RE: Proposed Development project located:

**816 Ormond Street, Venice FL 34285 Parcel #0175-11-0225;**

**City Petition #25-45SP**

## Perspective Views

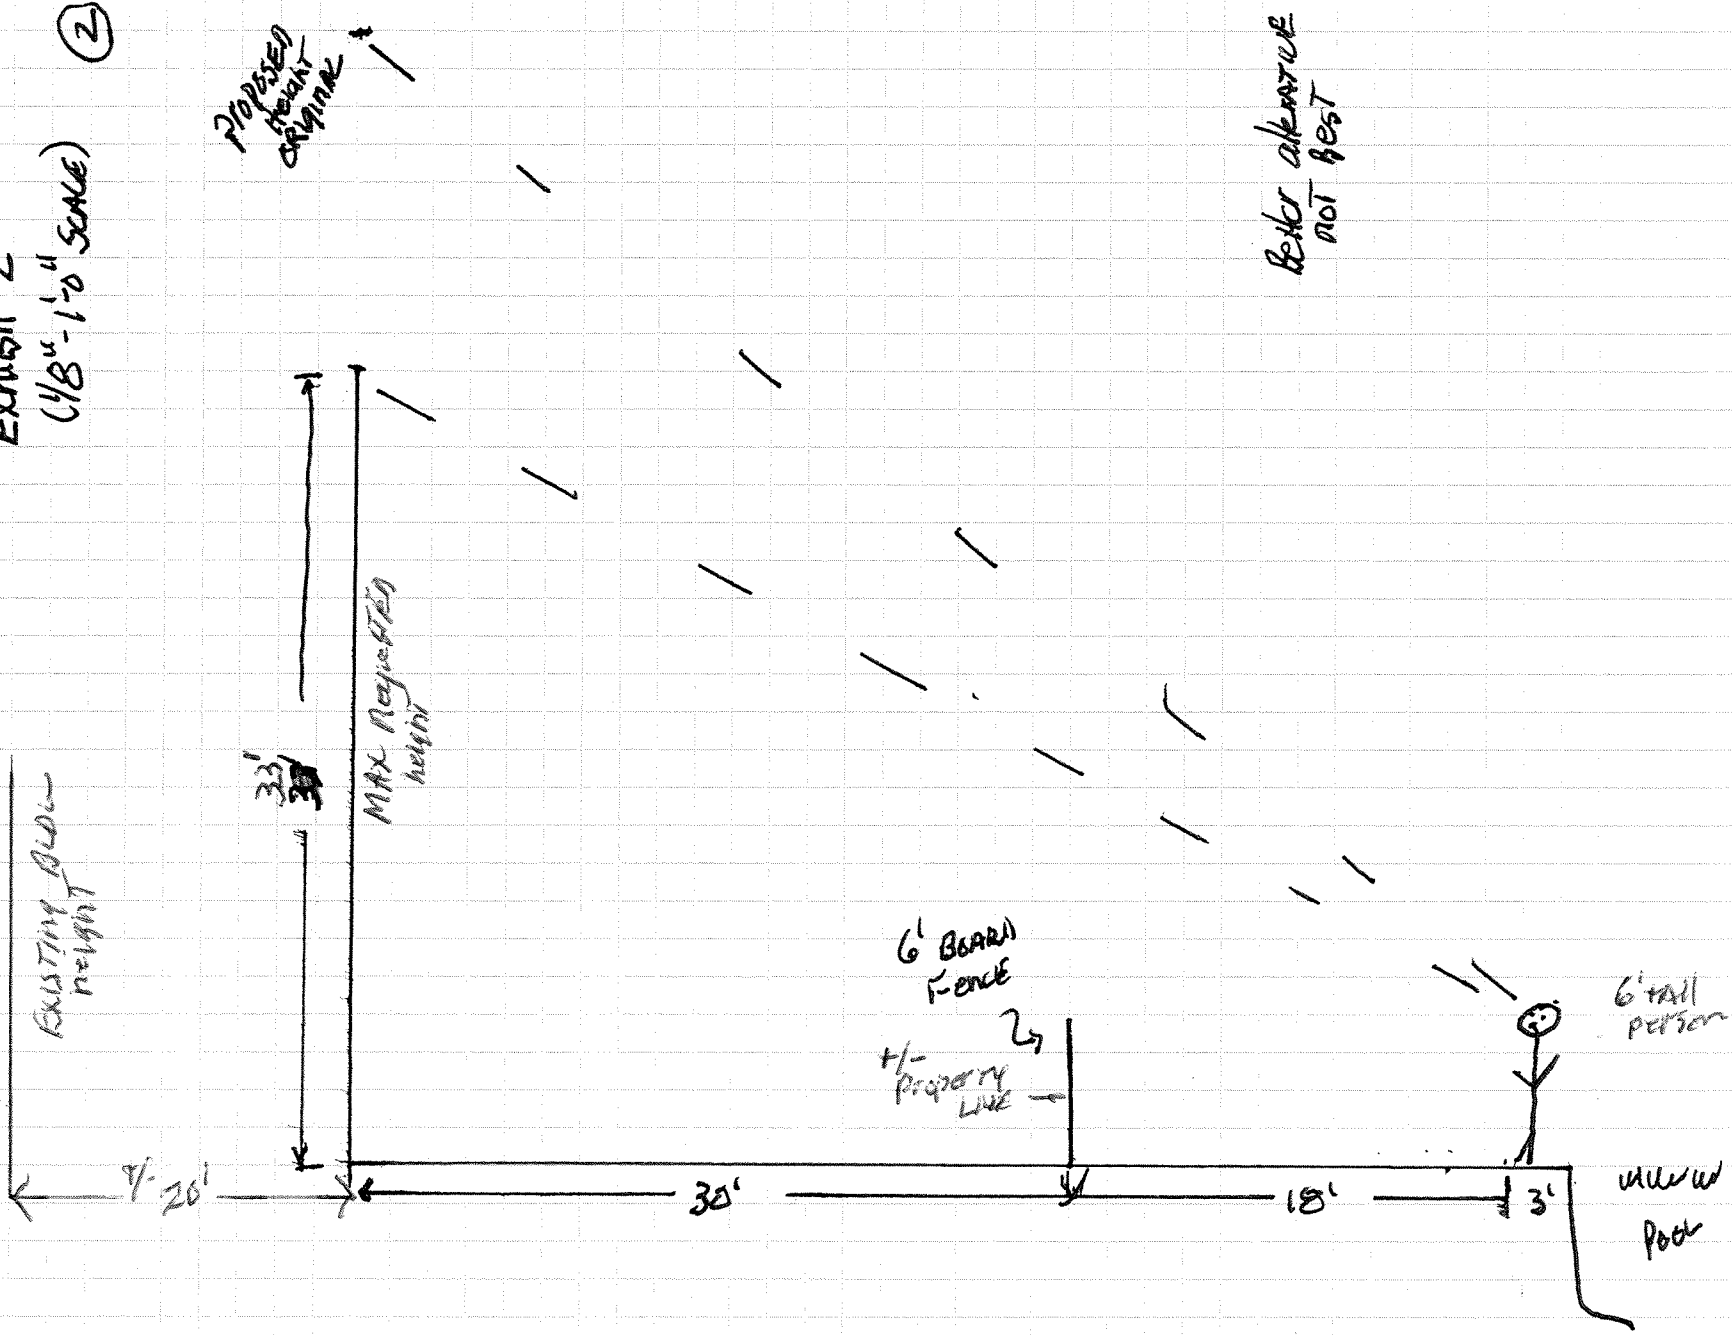
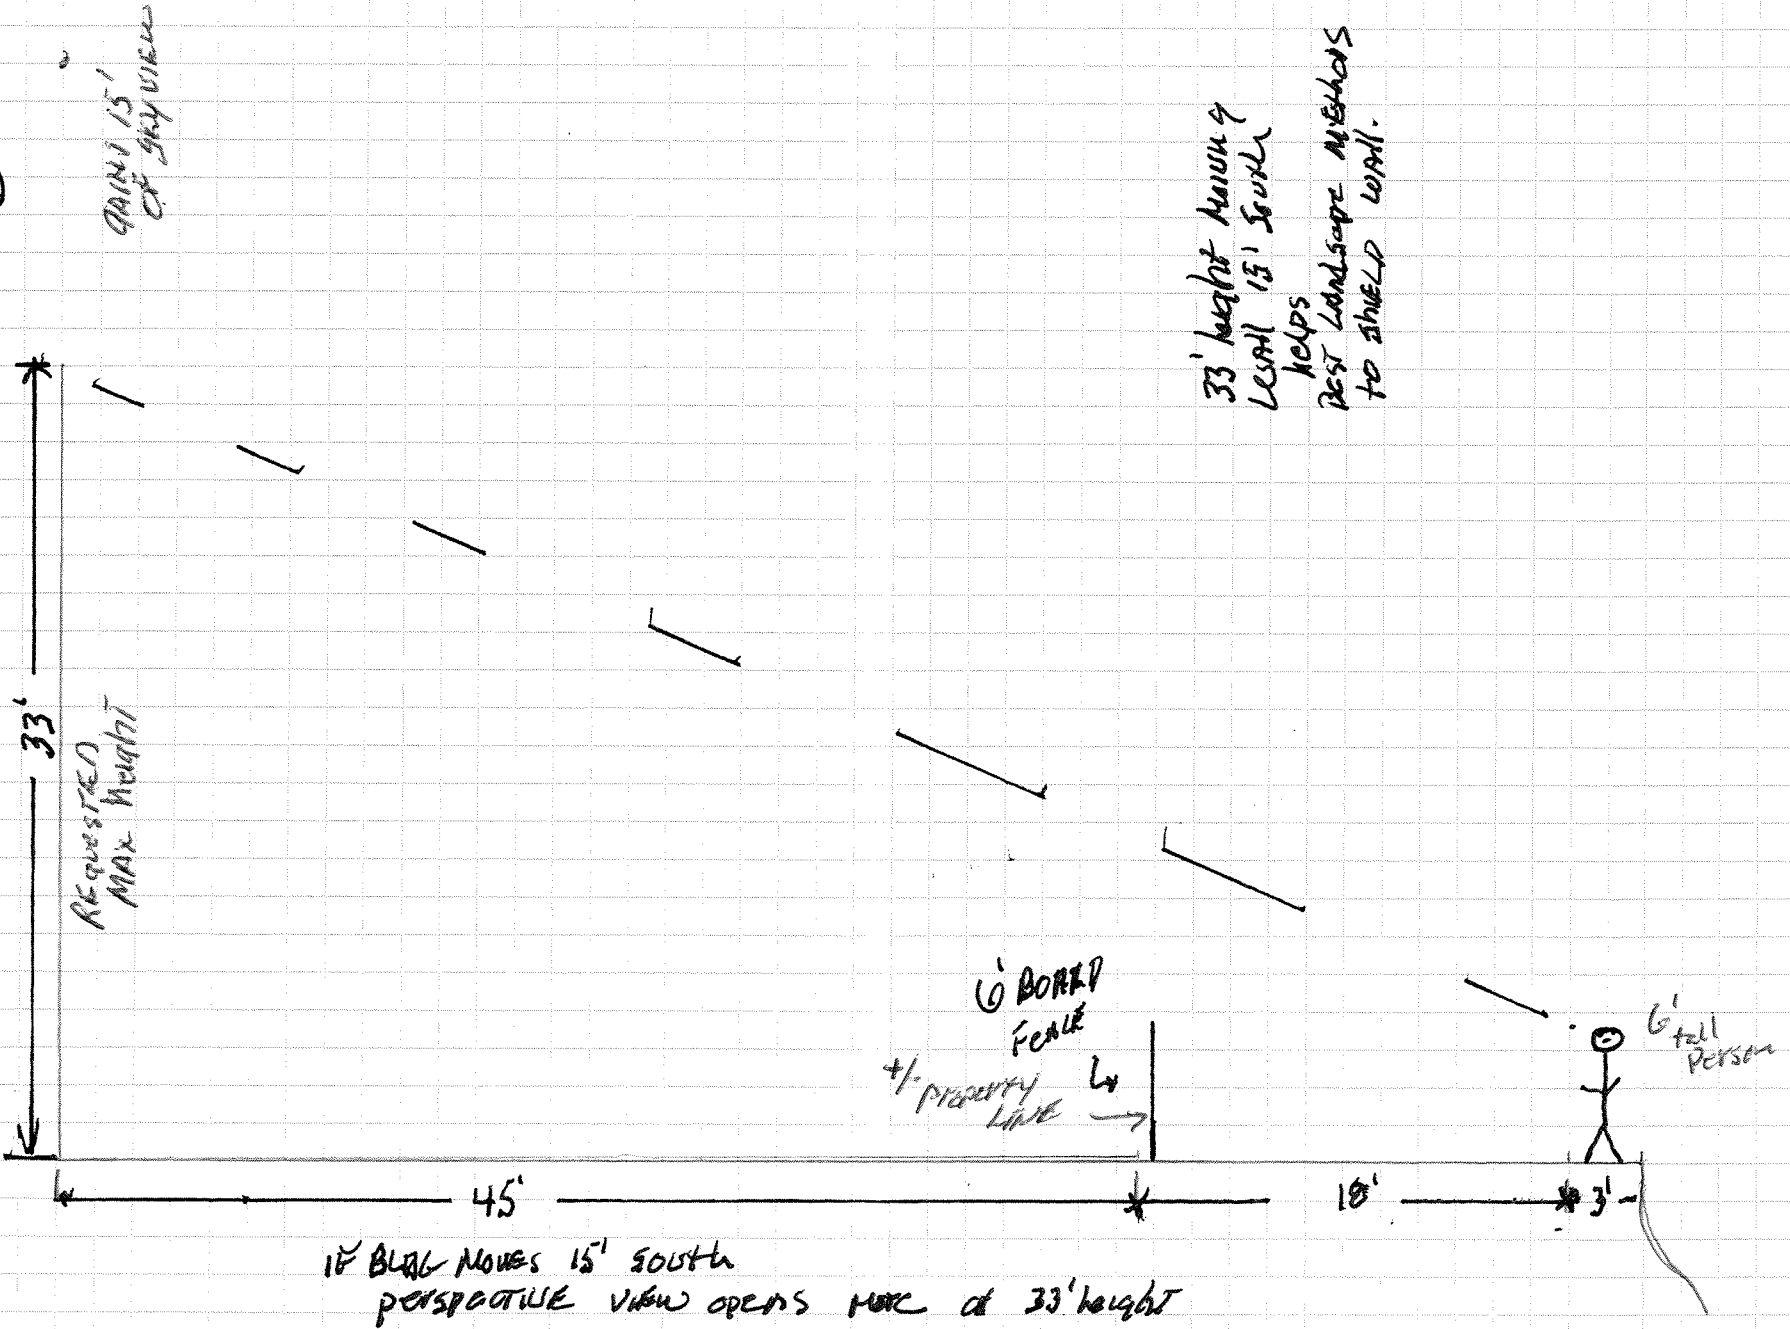
30° OF SKY SPACE IS LOST

PRIVACY IS GONE ON MY PROPERTY

30'  
FROM PROPERTY LINE TO BUILDING

**#1** The current proposed footprint of the 6-unit structure is placed at all setback points placing the structure 30.8' from fence lines on three properties on Madrid Avenue along with two properties on Ormond. The current height as proposed is 47.5' when the surrounding homes max in height is 28'. If allowed, this 6-unit building will violate all sky space, natural lighting, wind loads and privacy of existing residents with a virtual wall (please see perspectives in narrative 10-12).
